Errata Sheet

9 July 2001 / Release 1.4

Device: C515C-8E
Stepping Code / Marking: BB
Package: P-MQFP-80

CAN.4: Flowchart sequence in figure in User's Manual regarding Micro-controller handling of the Last Message Object is partly incorrect

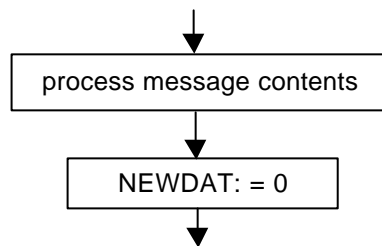
For the software flowchart figure 6-48 in User's Manual 11.97, the correct would be to first 'process message contents' and then to 'clear bit NEWDAT'.
